Re: Pond C and E inlet modifications, Coal Energy Group 2, LLC, Wildcat Load Out, Carbon County, Utah, C0070033

**ADDENDUM
TO
APPENDIX R**

**SEDIMENT PONDS C AND E
INLET MODIFICATIONS**

**COAL ENERGY GROUP 2
WILDCAT LOADOUT**

COAL ENERGY GROUP 2
WILDCAT LOADOUT
PLATE 2A
DRAINAGE MAP

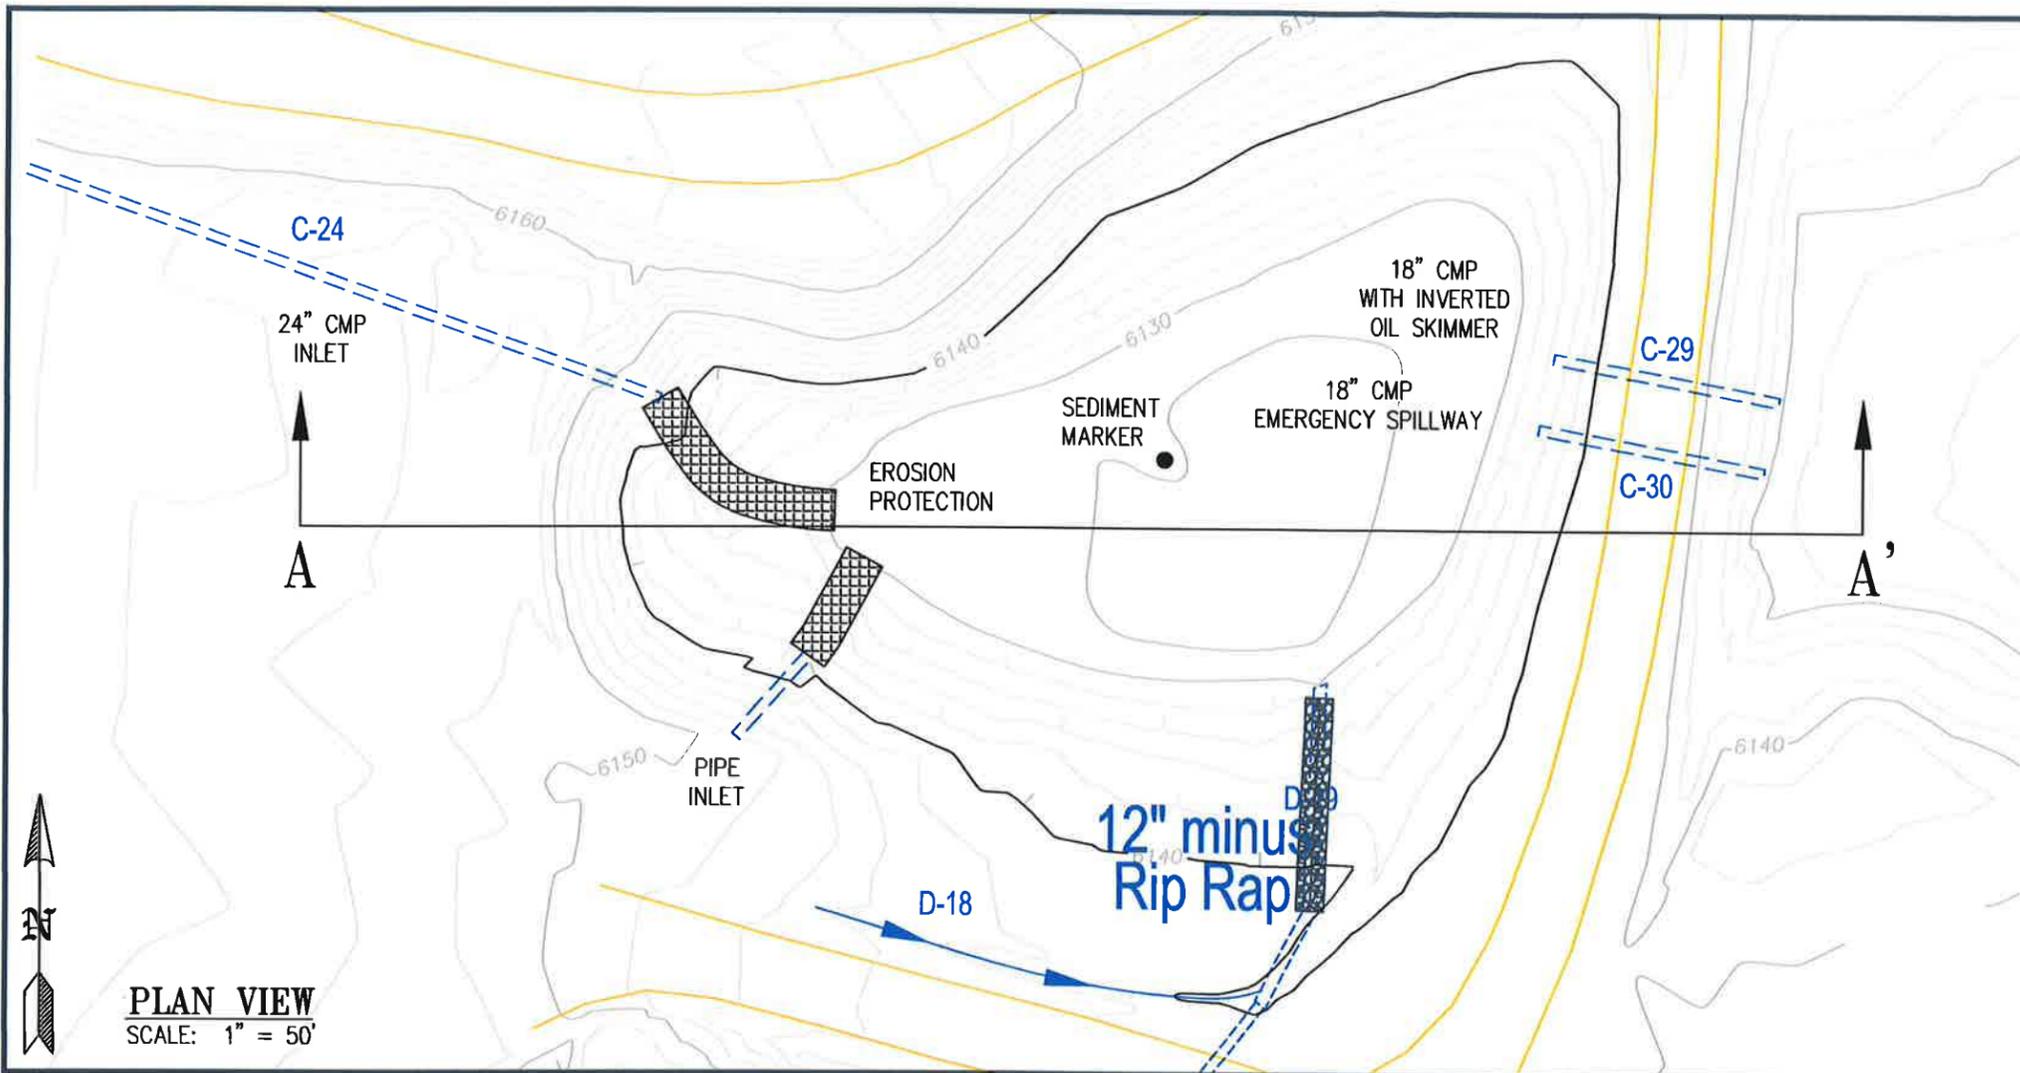
The inlets to Sediment Ponds C and E that were previously fitted with half-round culverts have been modified to provide more adequate erosion control. The half-round culvert into Pond C has been completely removed and replaced with a rock-armored ditch. The half-round culvert in the lower portion of the inlet into Pond E has also been removed and replaced with a rock-armored ditch. The half-round culvert above has been left in place. The new inlet configurations are shown on Plates 2A, 3C and 3E.

I, Dan W. Guy, a Registered Professional Engineer, State of Utah No. 154168, do hereby certify that the modifications to the inlets of Sediment Ponds C and E shown on this revision 6, are true and accurate to the best of my knowledge.

WILDCAT LOADOUT
SEDIMENT POND "C"
EXISTING

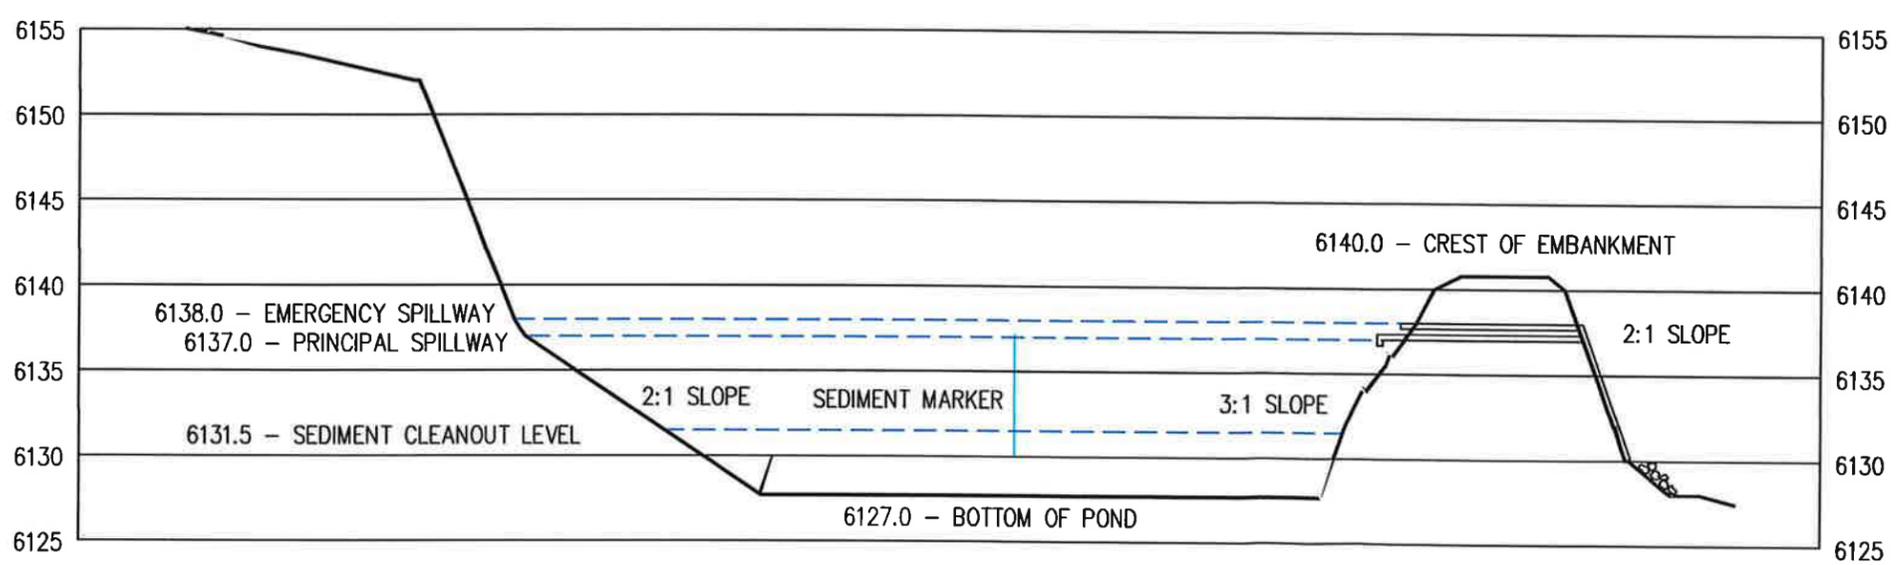
The half-round culvert inlet into Pond C was completely removed. The ditch was then cleaned out and lined with minus 2" bedding material and then completely armored with 12" minus rock rip-rap. The resulting ditch is 6' - 8' wide at the top and approximately 34" deep, which is considerably larger than the culvert area. The modified area is approximately 51' in length with a slope of 12 degrees.

The inflow from a 10 yr. / 24 hr. storm event for this inlet is calculated to be 11.14 cfs with a flow velocity of 6.76 fps, as shown for Ditch D-19 on Table 6 of Appendix R. This flow was checked against the Rip-Rap Chart – Figure 2 in Appendix R. Using a worst-case scenario of 1:1 side slopes and the flow velocity of 6.76 fps, the rip-rap size should be approximately 8". The 12" minus material used is therefore considered adequate to resist displacement.

**WILDCAT LOADOUT
SEDIMENT POND "E"
EXISTING**

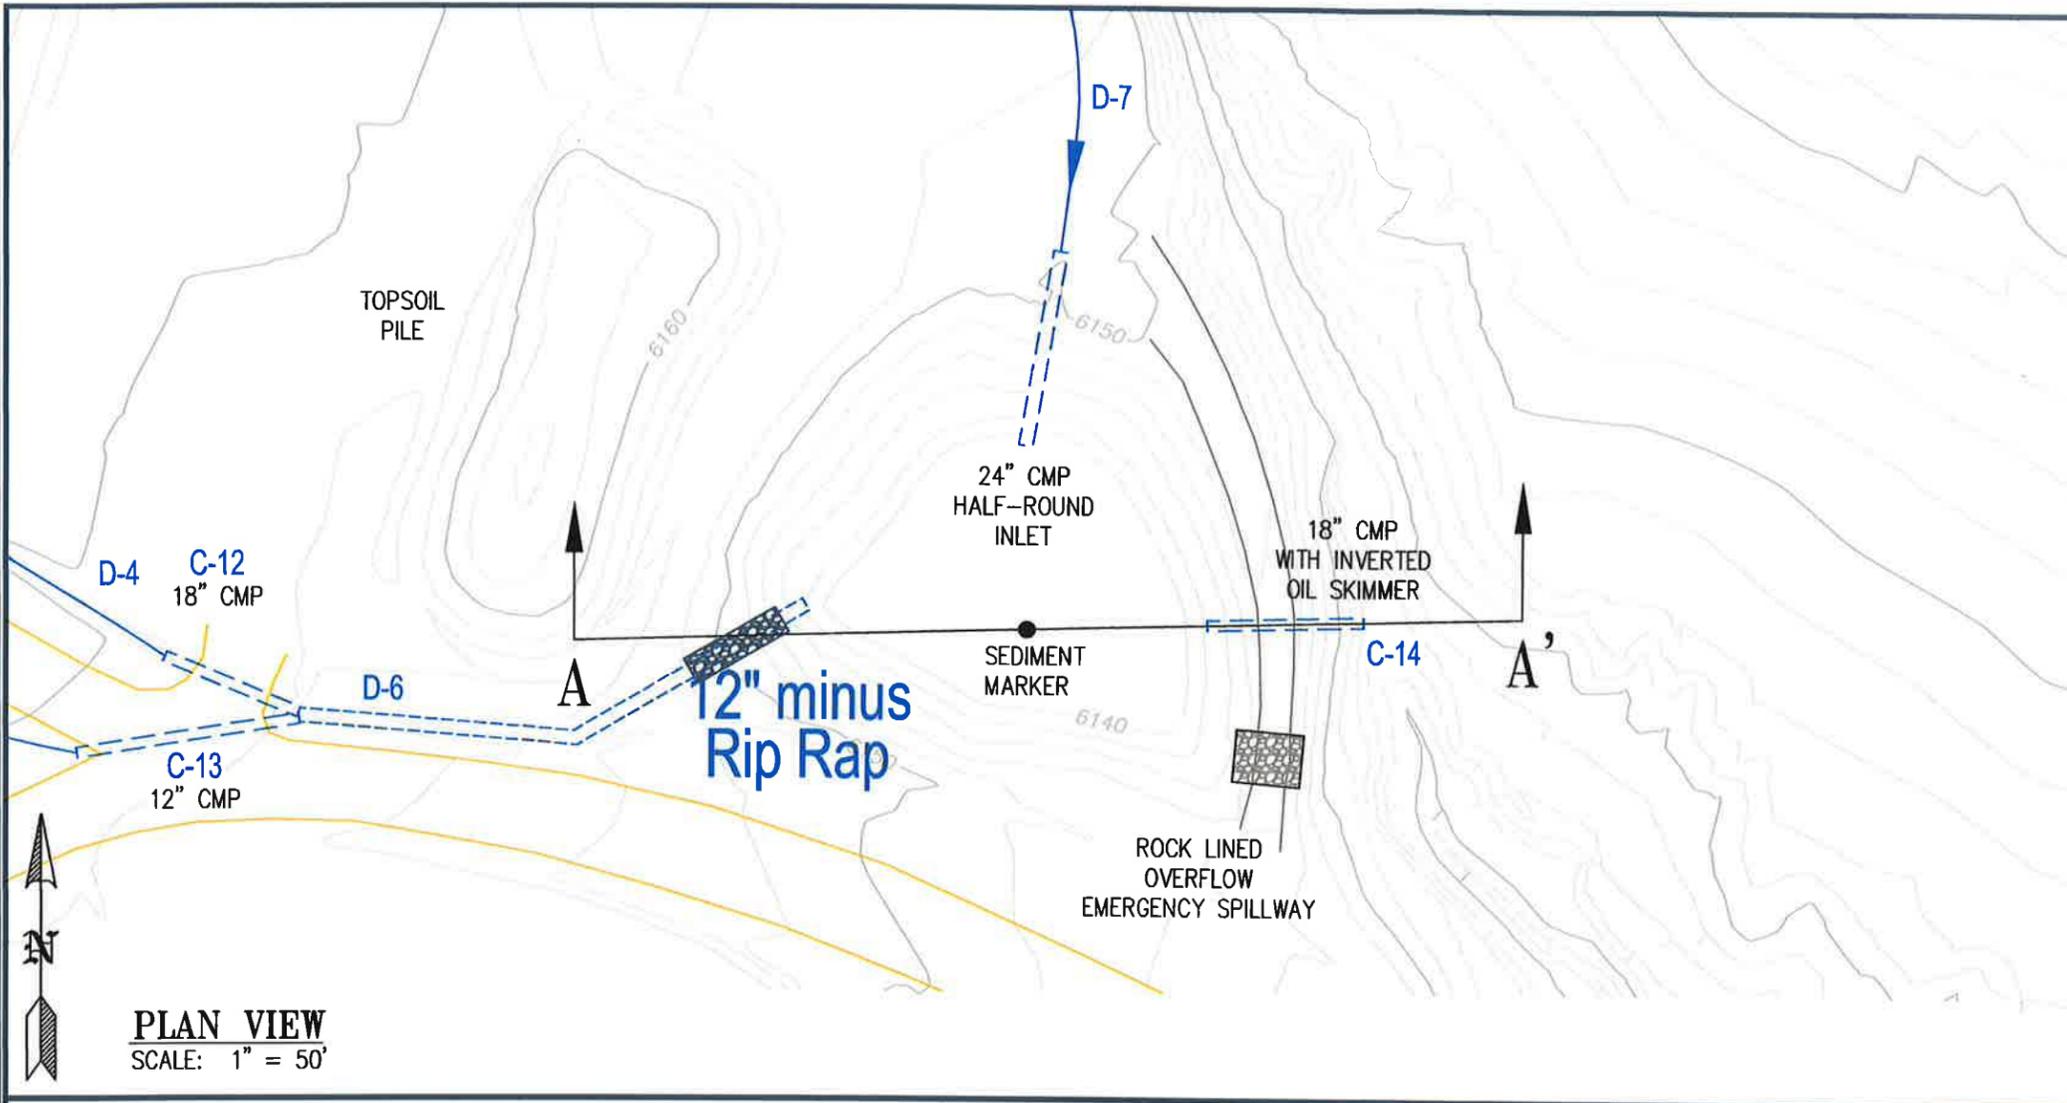
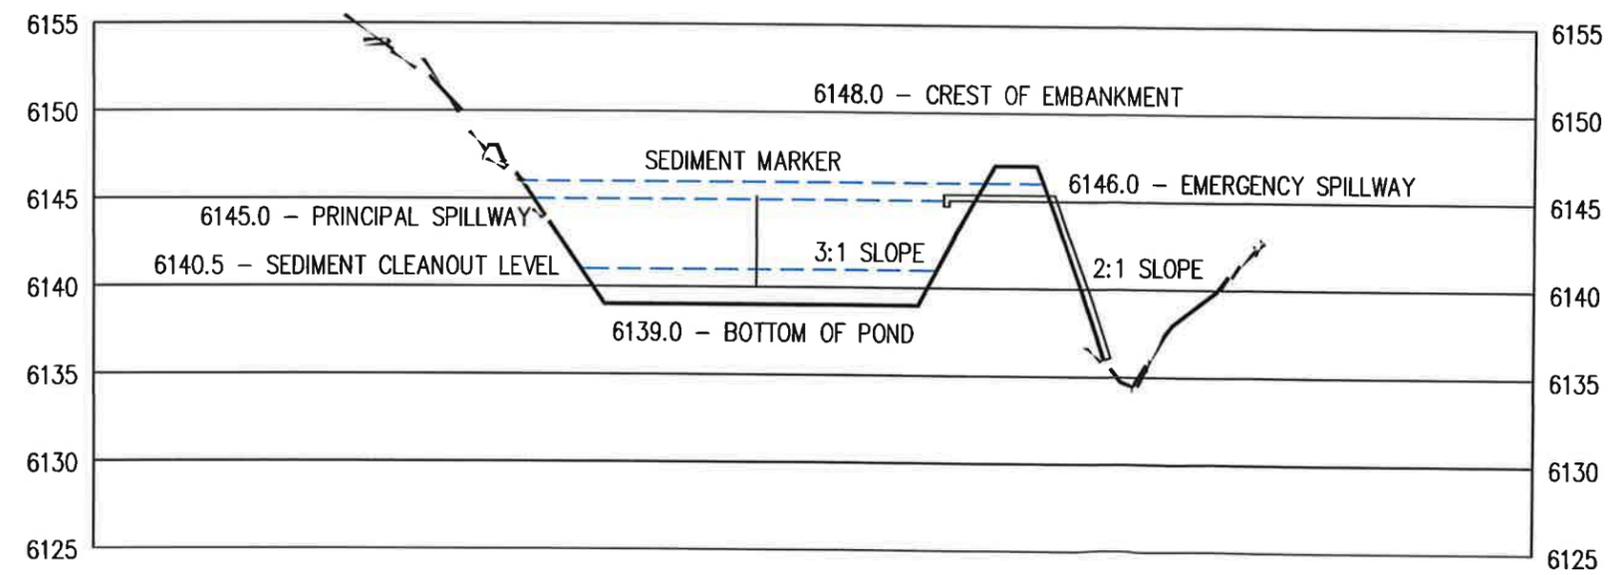
Only the lower portion of the half-round culvert inlet into Pond E has been replaced. This is a relatively small section of approximately 25' in length where the slope steepened and the culvert was being undercut. The modification here was the same as in Pond C above. The culvert was removed and the ditch was cleaned out and reshaped. The ditch was then lined with the minus 2" bedding material and then armored with the 12" minus rock rip-rap. The rip-rapped ditch is 6' - 8' wide at the top and approximately 30" deep, which is also larger than the previous culvert area. The modified area here is approximately 25' in length with a slope of 20 degrees.

The inflow from a 10 yr. / 24 hr. storm event for this inlet is calculated to be 7.77 cfs with a flow velocity of 6.07 fps, as shown for Ditch D-6 on Table 6 of Appendix R. This flow was also checked against the Rip-Rap Chart as mentioned above. Using the worst-case scenario of 1:1 side slopes and the flow velocity of 6.07 fps, the rip-rap size should be approximately 6". The 12" minus material used is also considered adequate to resist displacement in this modified inlet.
